## **Addendum No. 2**

Date: *May 4, 2023*  
Solicitation Number: *FY23-ITBCON-26*  
Title: *Beaverdam Creek Pump Station Expansion*

**Subject:** Addendum No. 2

**Project:** Beaverdam Creek Pump Station Expansion Project

Location of Discharge Manhole  
C-410 Bid Form 5.24.19, Page 3

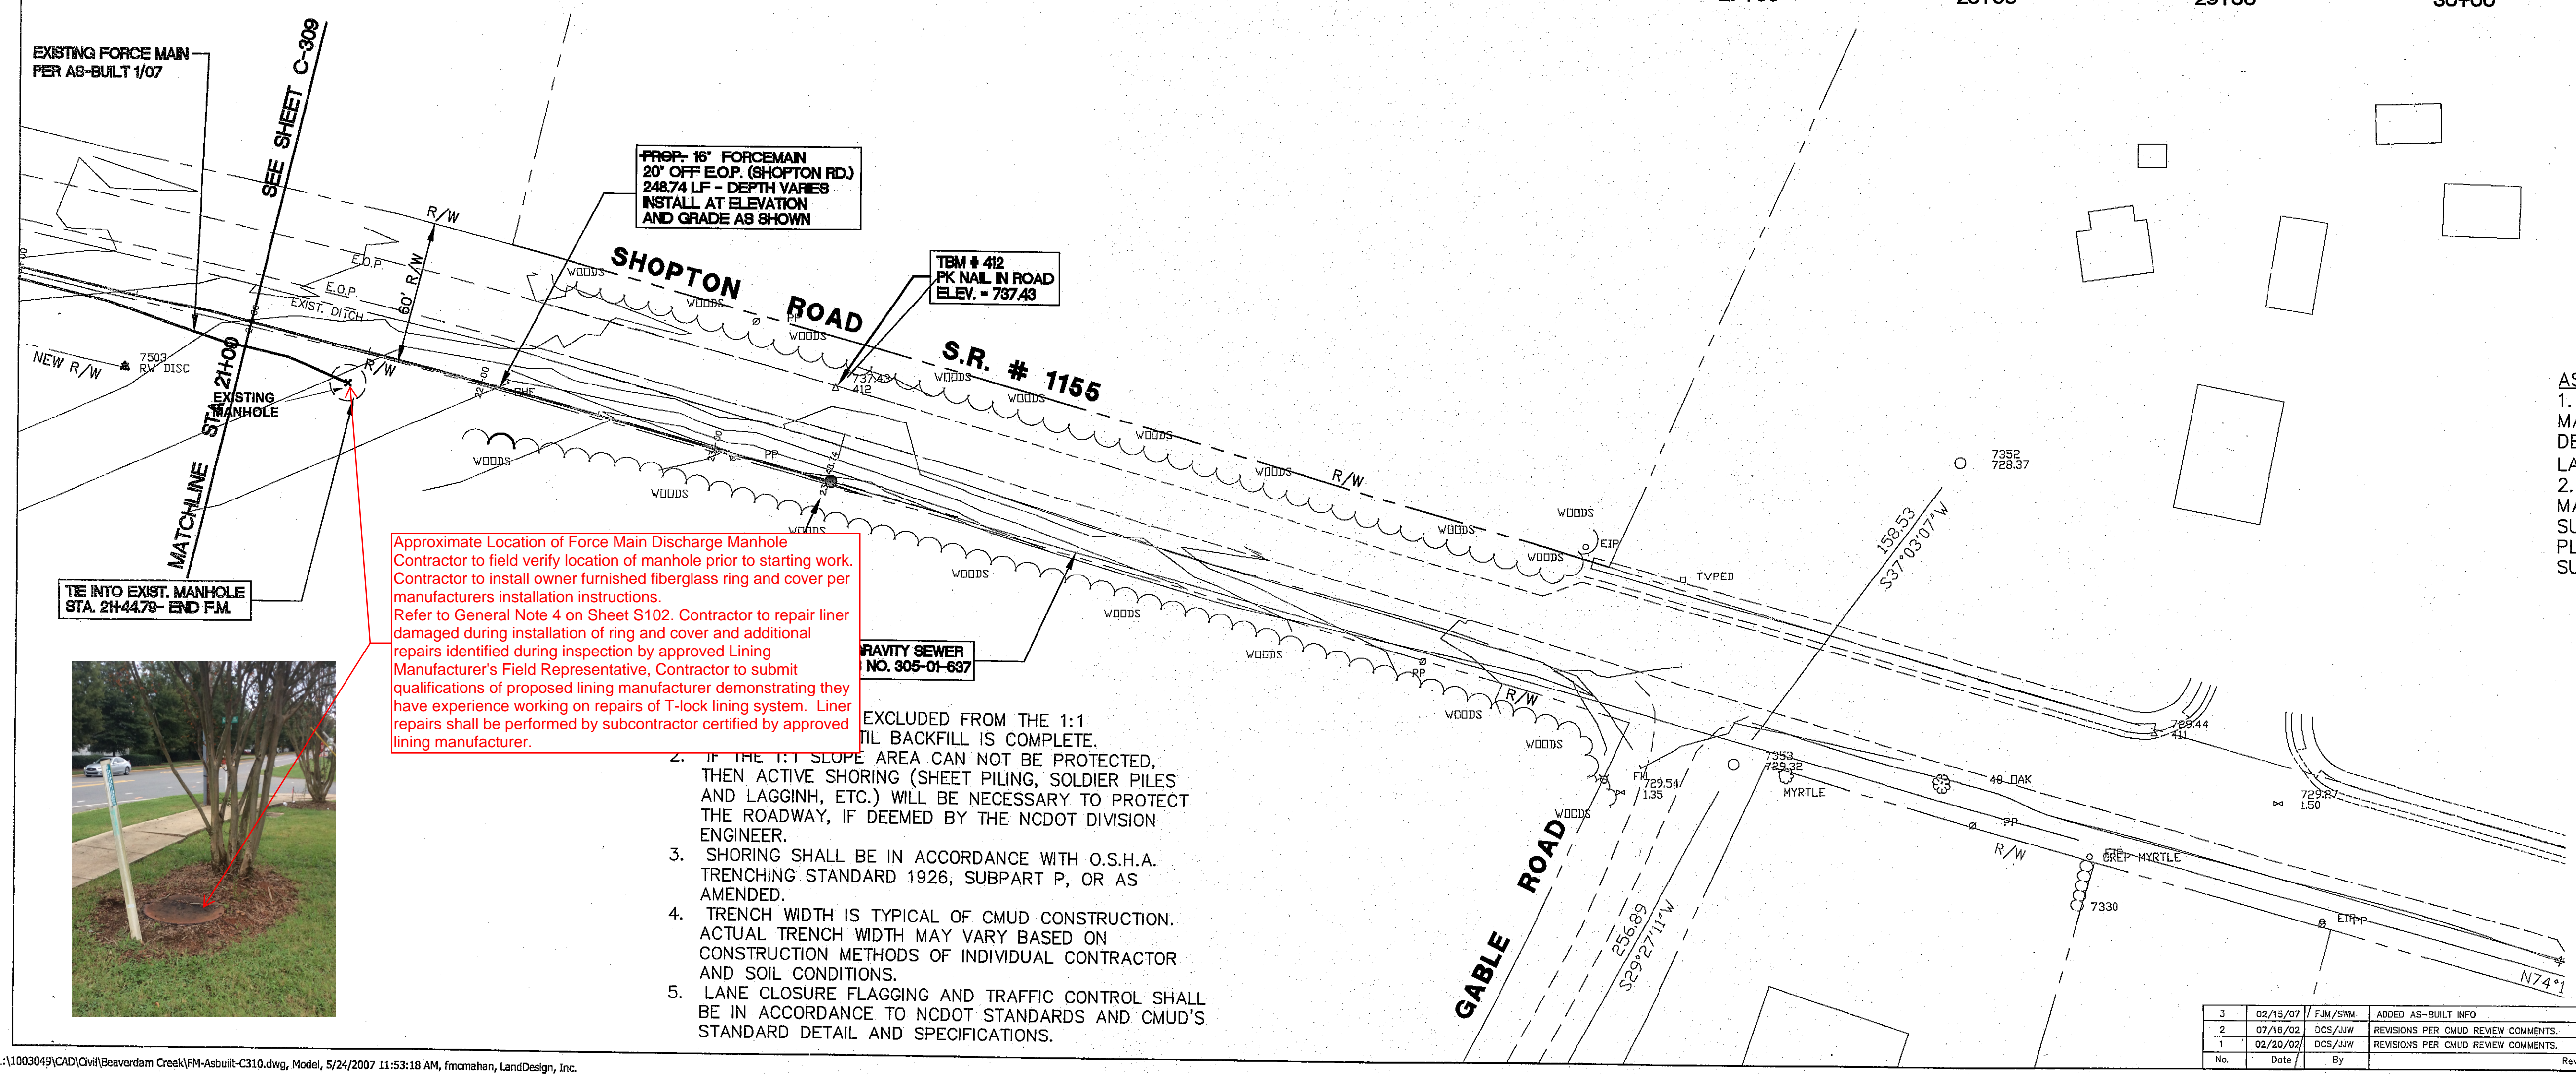
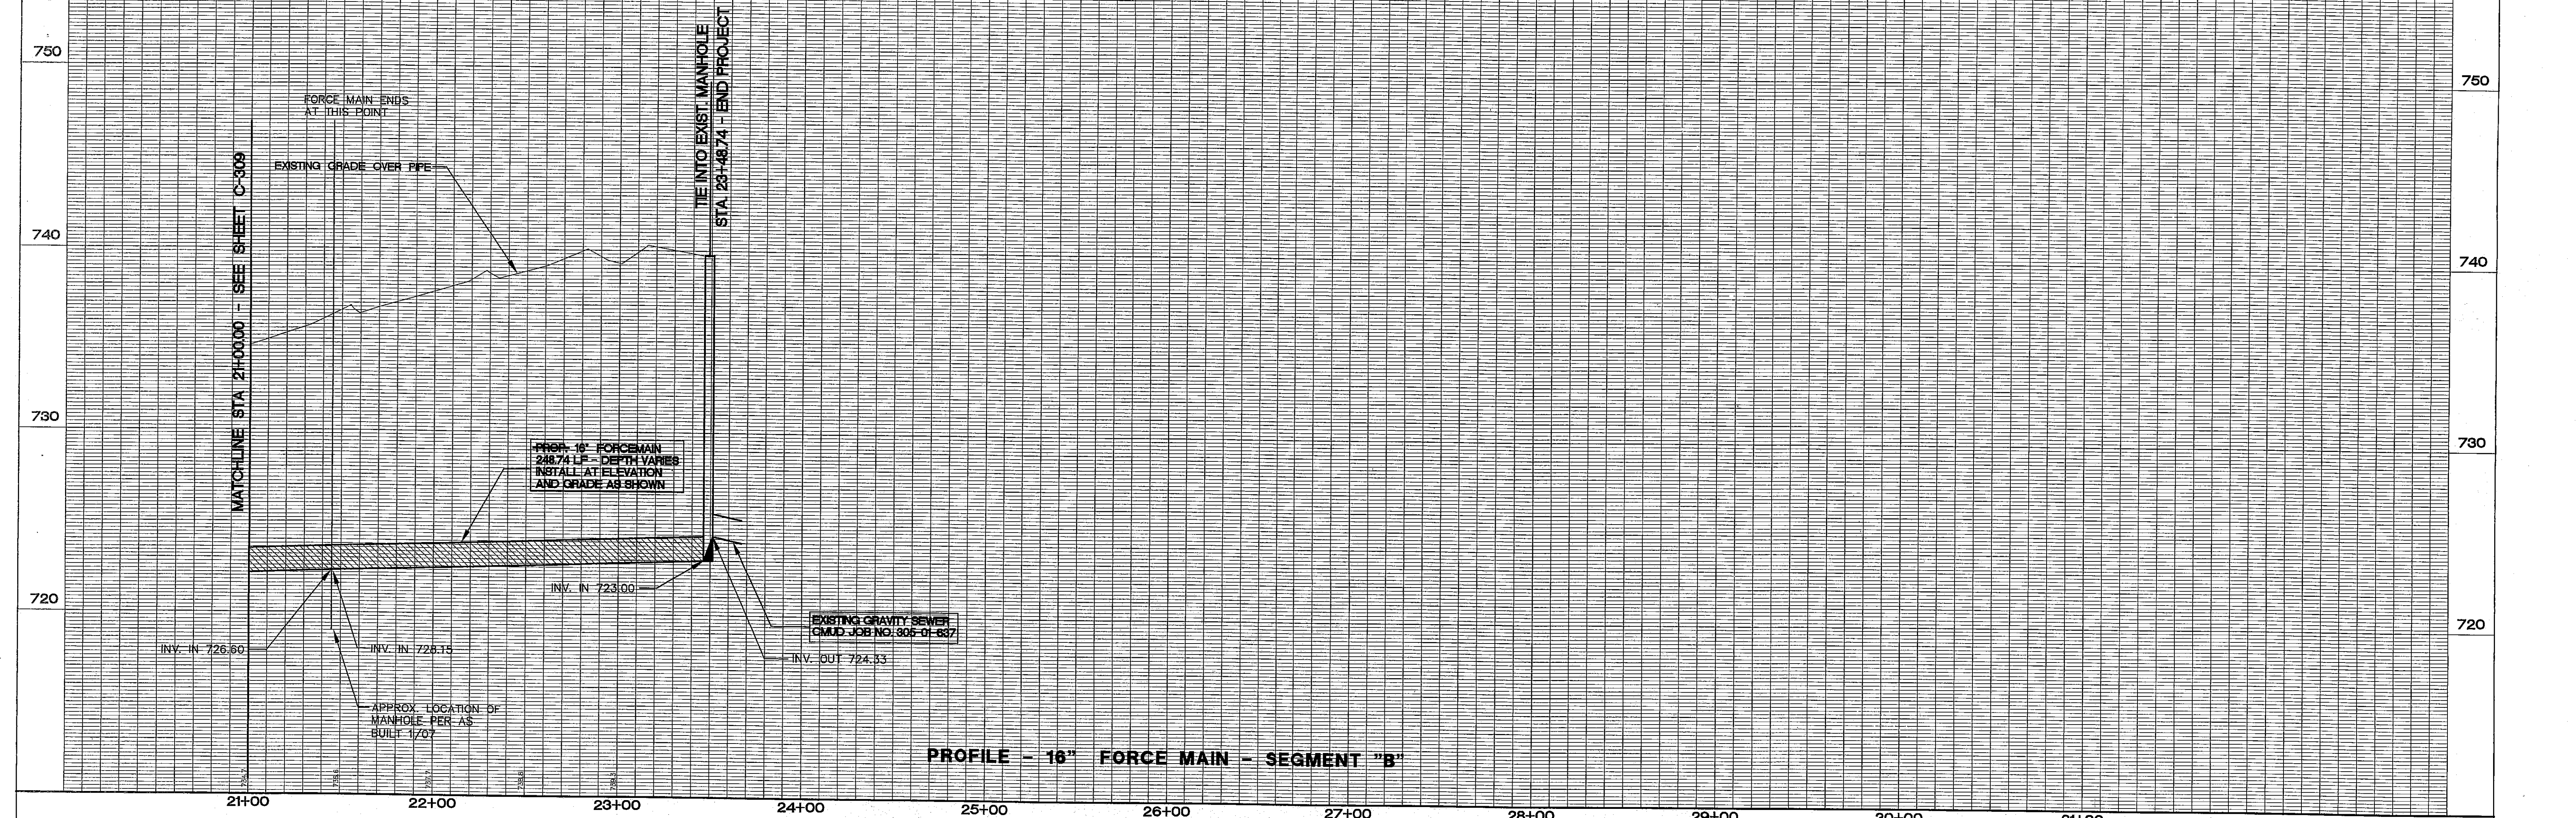
2. *The manhole noted on Drawing C020 has a hatch. Does Charlotte Water want this replaced with the cone and cover?*

Approximate Location of Force Main Discharge Manhole  
Contractor to field verify location of manhole prior to starting work.  
Contractor to install owner furnished fiberglass ring and cover per manufacturers installation instructions.  
Refer to General Note 4 on Sheet S102. Contractor to repair liner damaged during installation of ring and cover and additional repairs identified during inspection by approved Lining Manufacturer's Field Representative. Contractor to submit qualifications of proposed lining manufacturer demonstrating they have experience working on repairs of T-lock lining system. Liner repairs shall be performed by subcontractor certified by approved lining manufacturer.

No, this note will be deleted. See Attachment Location of Discharge Manhole. This is the location where the Contractor shall install the Owner furnished fiberglass ring and cover.
